**Re: Montano Plaza/ Building C**  
**6200 Coors Blvd. NW**  
**Traffic Circulation Layout**  
Engineer's Stamp 08-02-24 (E12-D003G)

Based upon the information provided in your submittal received 08-02-24, the above referenced plan cannot be approved for Building Permit until the following comments are addressed:

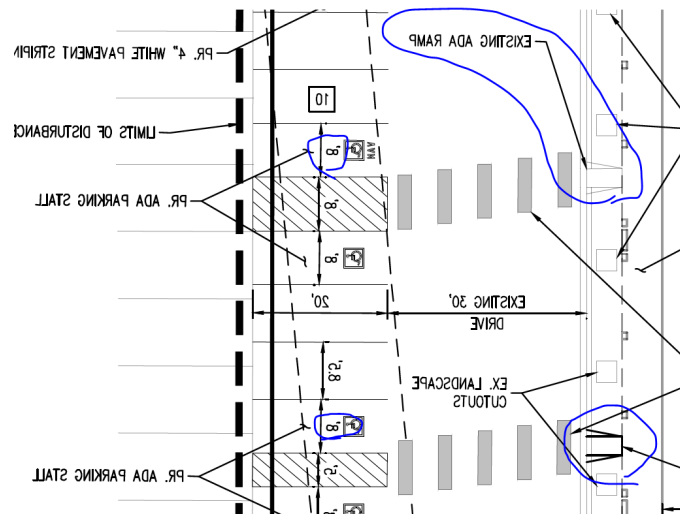
3. The ADA accessible parking sign must have the required language per 66-7-352.4C NMSA 1978 **"Violators Are Subject to a Fine and/or Towing."** Please call out detail and location of signs.
4. The ADA access aisles shall have the words **"NO PARKING"** in capital letters, each of which shall be at least one foot high and at least two inches wide, placed at the rear of the parking space so as to be close to where an adjacent vehicle's rear tire would be placed. (66-1-4.1. B NMSA 1978)
5. The minimum parking stall length is 18 ft.

FIGURE 7.4.115 Bicycle Parking Stall Layout Options

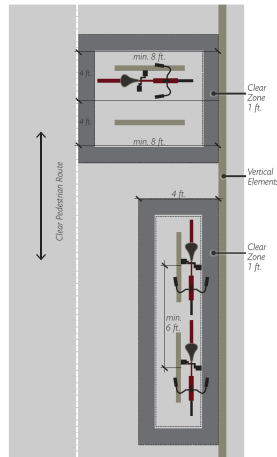
12. A 1-foot clear zone around the bicycle parking stall shall be provided.
13. Bicycle parking spaces shall be at least 6 feet long and 2 feet wide.

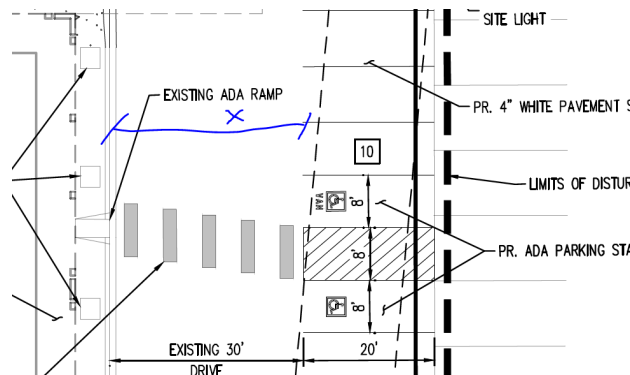
14. Show all drive aisle widths and radii. Some dimensions are not shown.

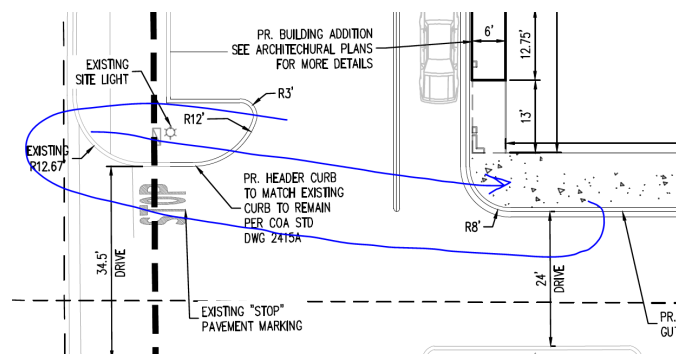
15. Per the IDO, a 6 ft. wide ADA accessible pedestrian pathway is required from the public sidewalk to the building entrances. Please clearly show this pathway and provide details. As a suggestion: develop an ADA ramp on the southwest side sidewalk to create the required ADA pathway.
